PROJECT TITLE: Bolton Animal Clinic ZONE ATLAS/DRNG. FILE #: L 15 / D40

Re: Bolton Animal Hospital Grading and Drainage Plan
Engineer's Stamp Dated 4-23-02, (L15/D40)

RE: DRAINAGE PLAN FOR BOLTON ANIMAL CLINIC (L15-D40) ENGINEER'S STAMP DATED 12/12/92.

Re: Bolton Animal Clinic (L15-D40)

DRAWING NO.	MAP NO.	SHEET OF
3824	L - 15	62 OF 80

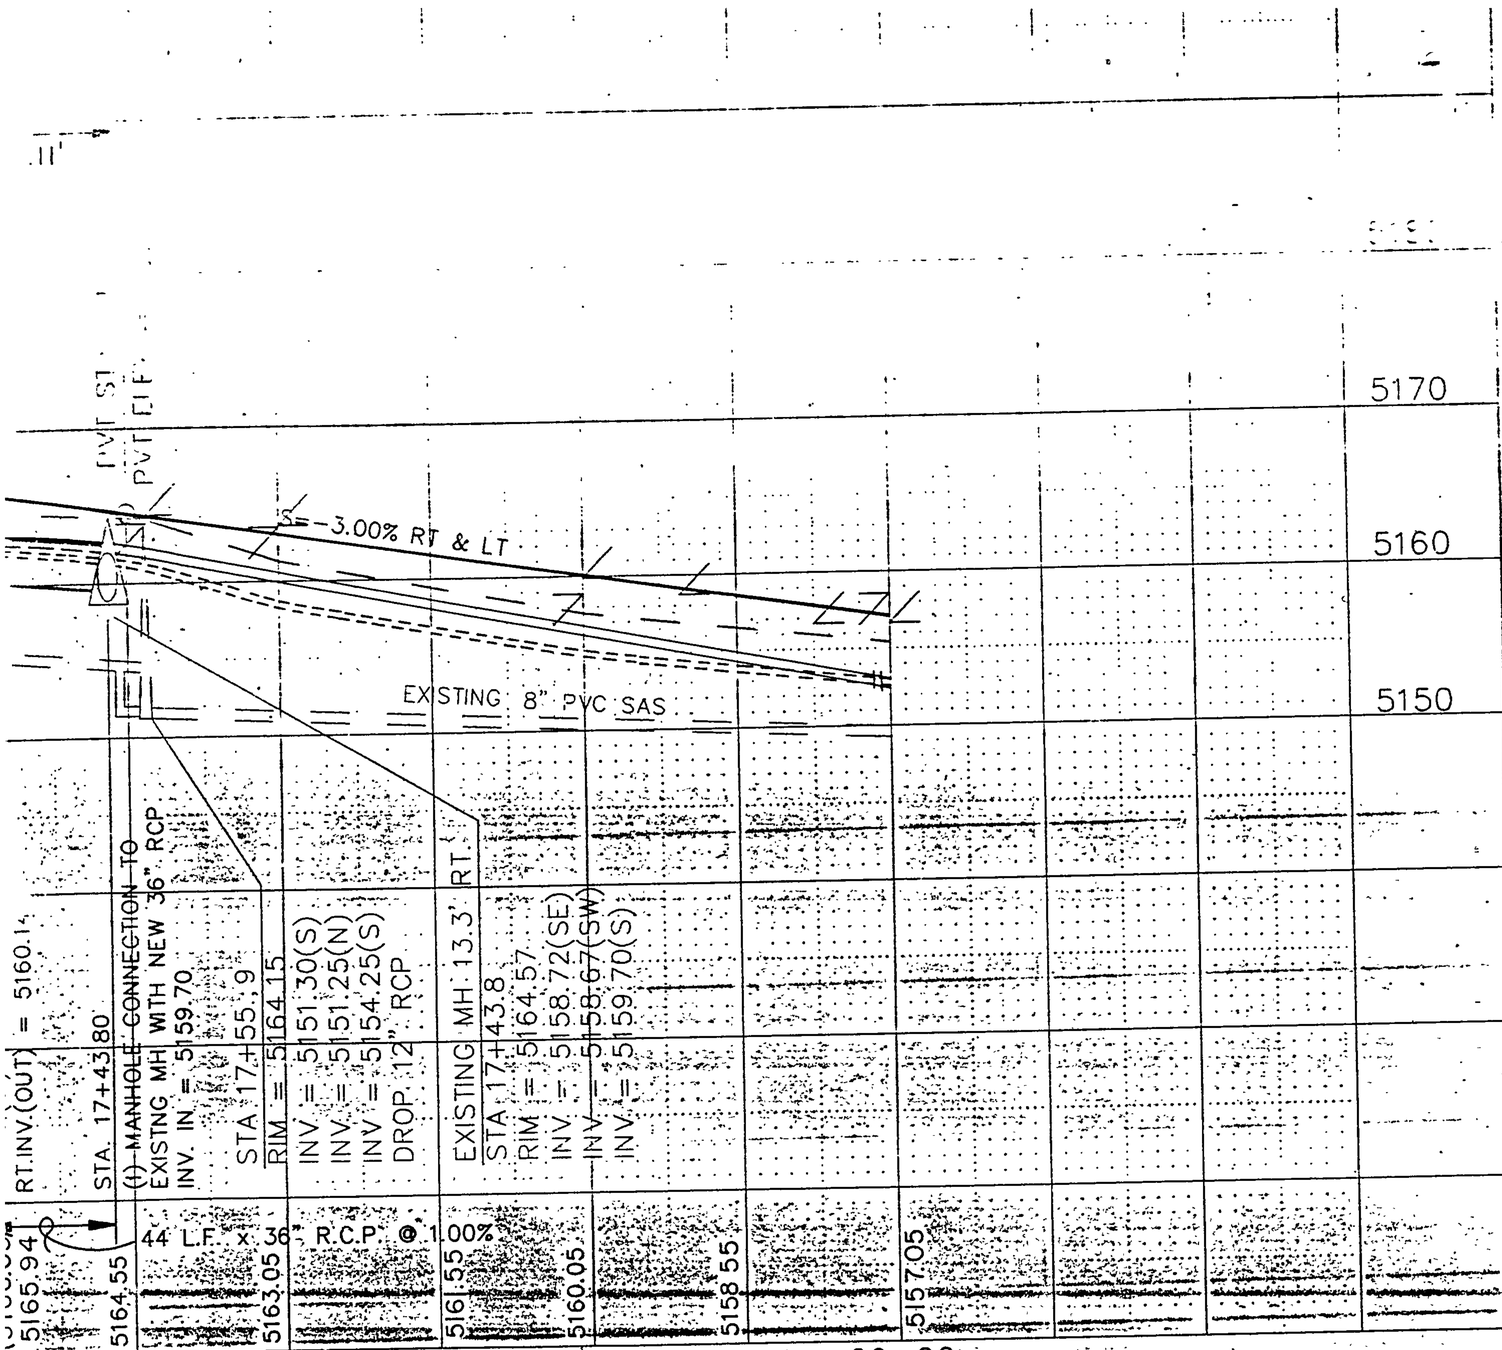
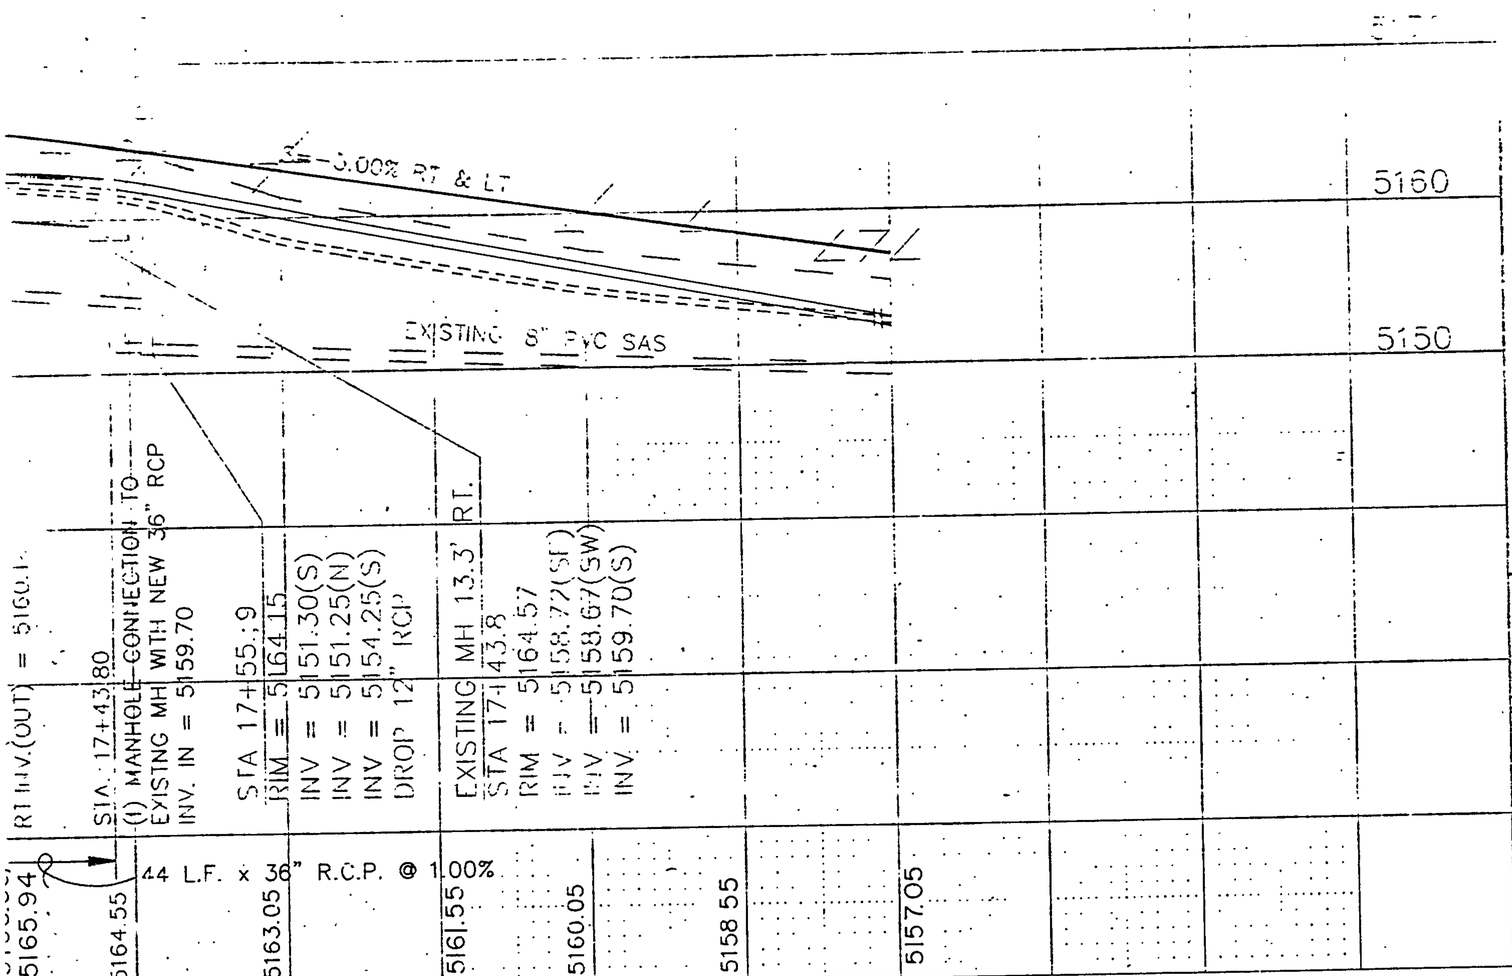
3. Status of S.A.D. 221 project 3824. Have the plans for project 3824 been signed off already for construction?

3. The plans provided to us by Wilson & Company for SAD 221 (City Project No. 3824) did not bear any DRC approval signatures. Enclosed you will find copies of the signature block from the pertinent sheets from the plan set. It is still our understanding, however, that the project will be constructed during the summer of 1993. You might wish to confirm this independently with Mr. Lee Lunsford, SAD Engineer, Public Works Department.

TOPOGRAPHY & SITE MAP
BOLTON ANIMAL HOSPITAL
LOTS 18, 19 & S. ½ 20 BLOCK 12 & TRACT B-1 CLAYTON HEIGHTS
NOVEMBER, 1991

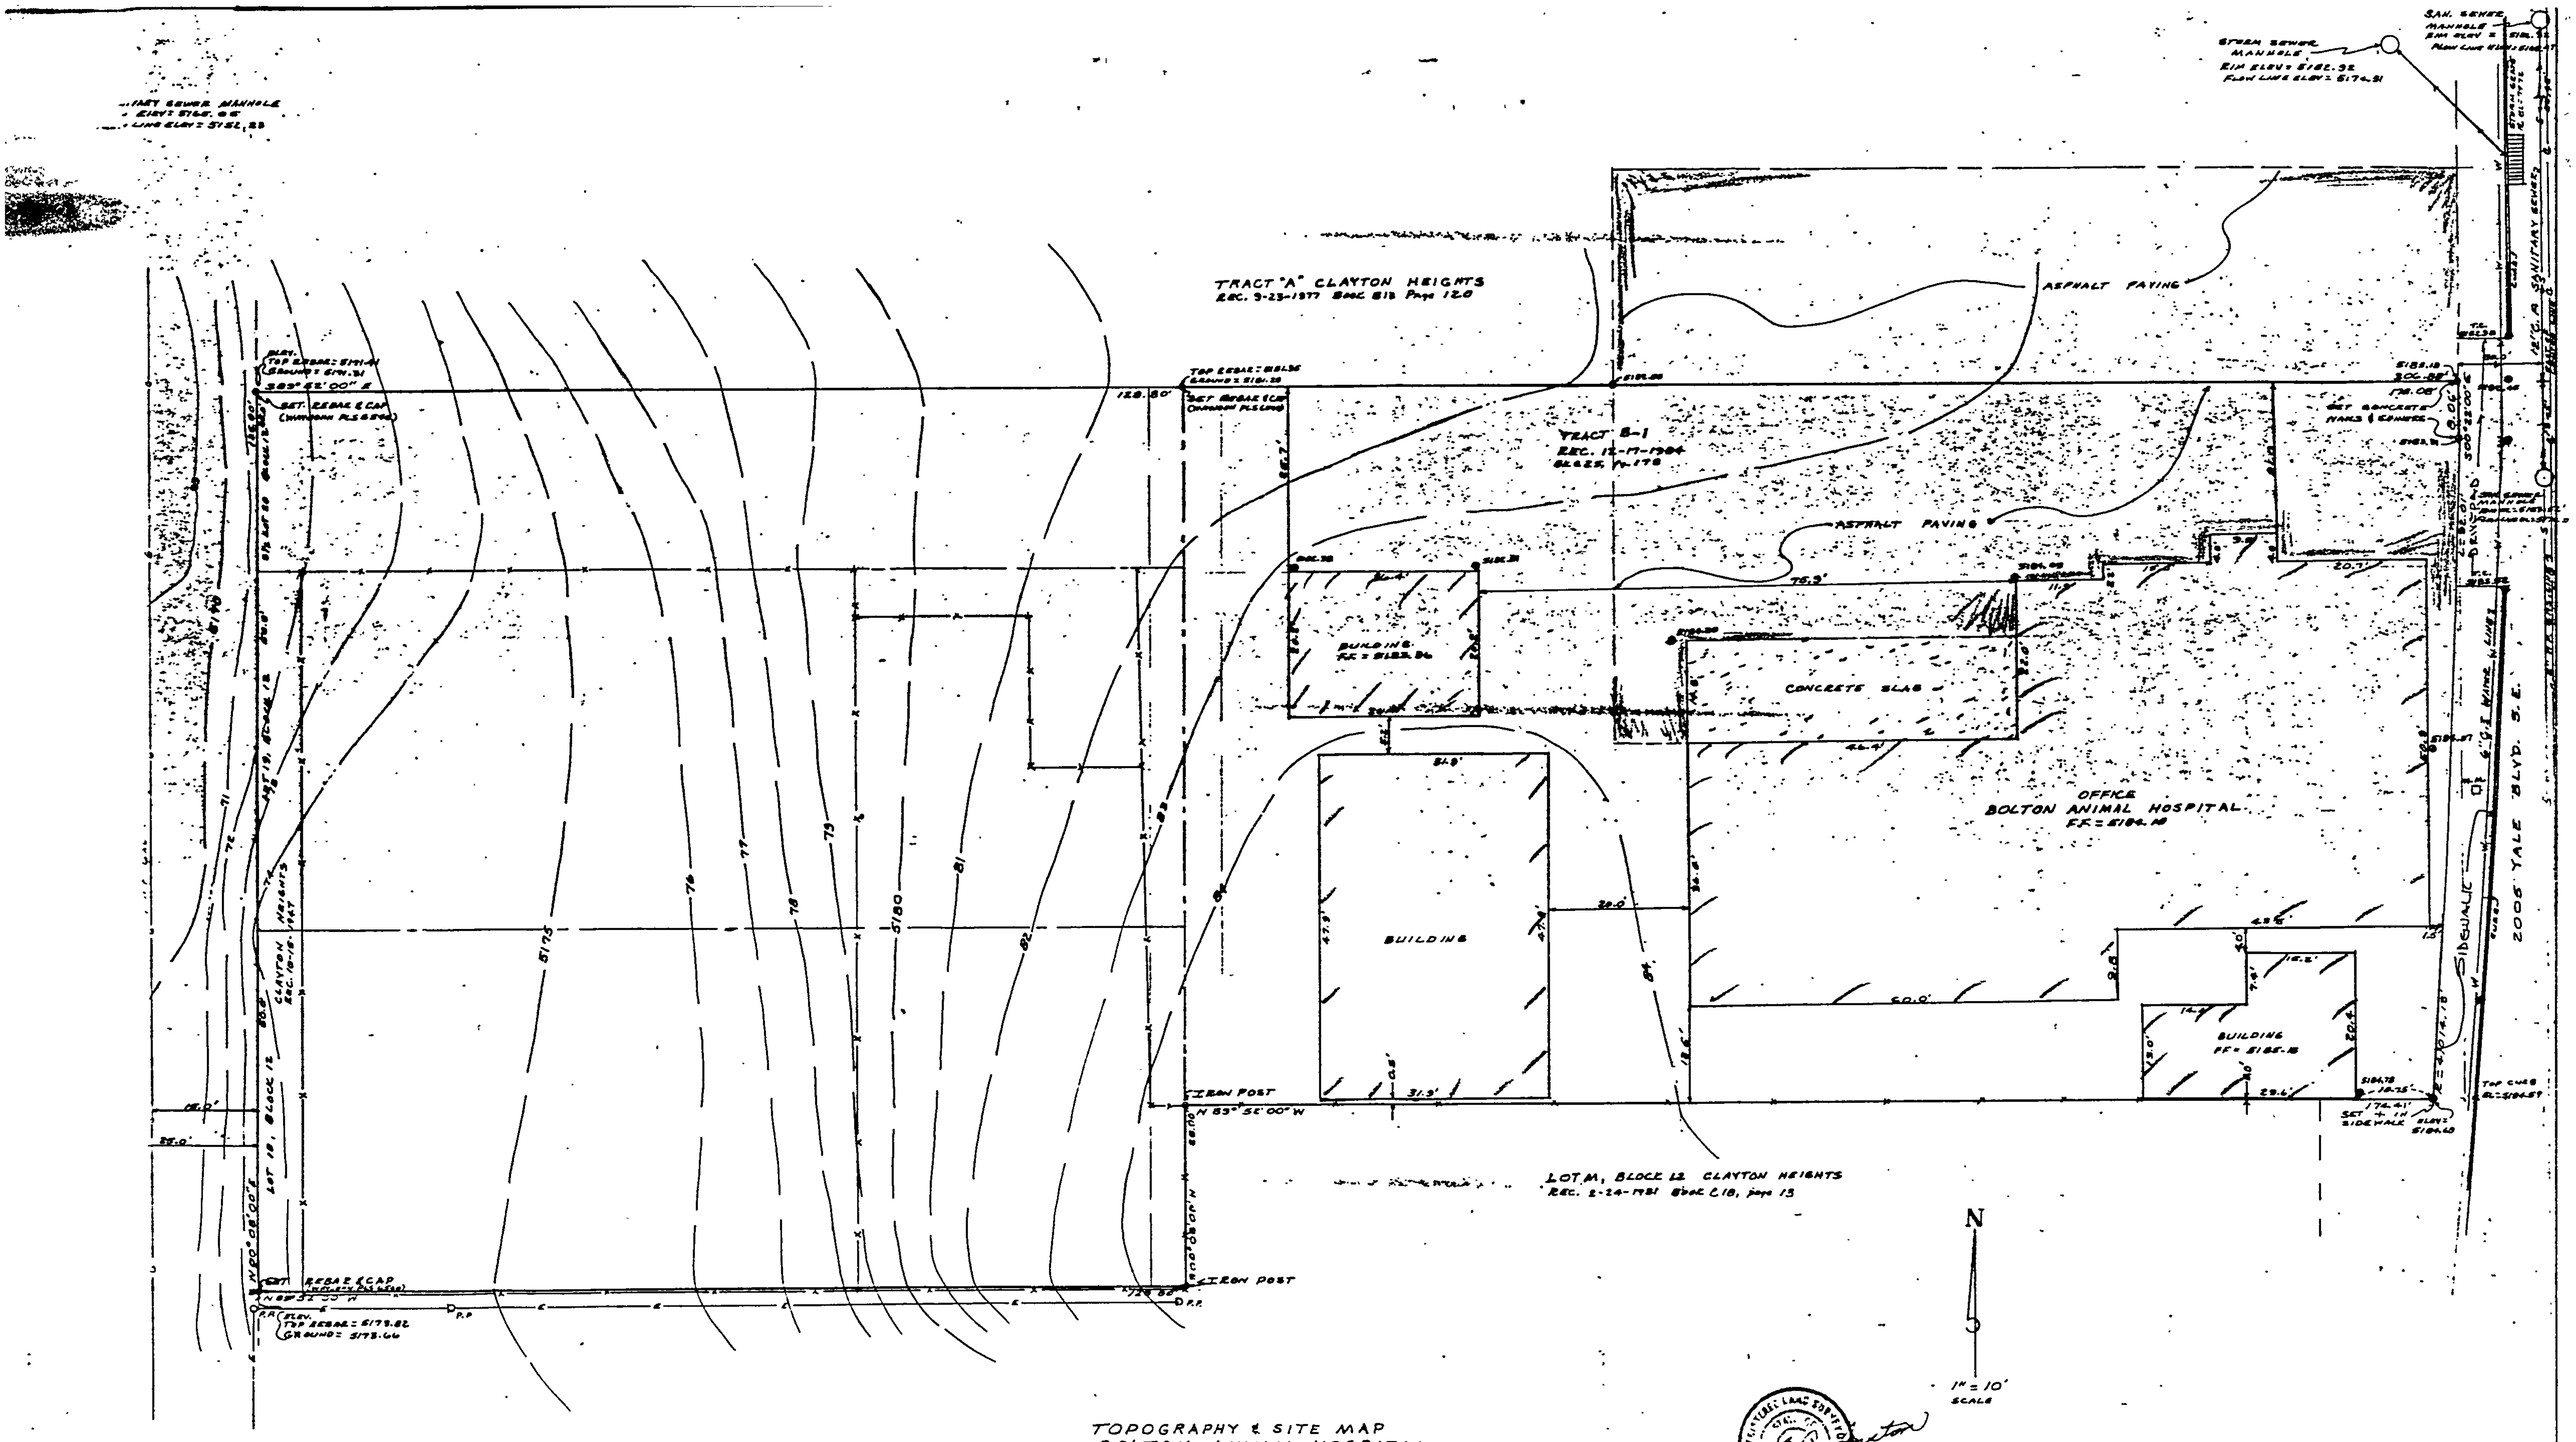
6. Copy of topographic will need to be included with resubmittal.

6. A copy of the topographic survey is provided for your reference.
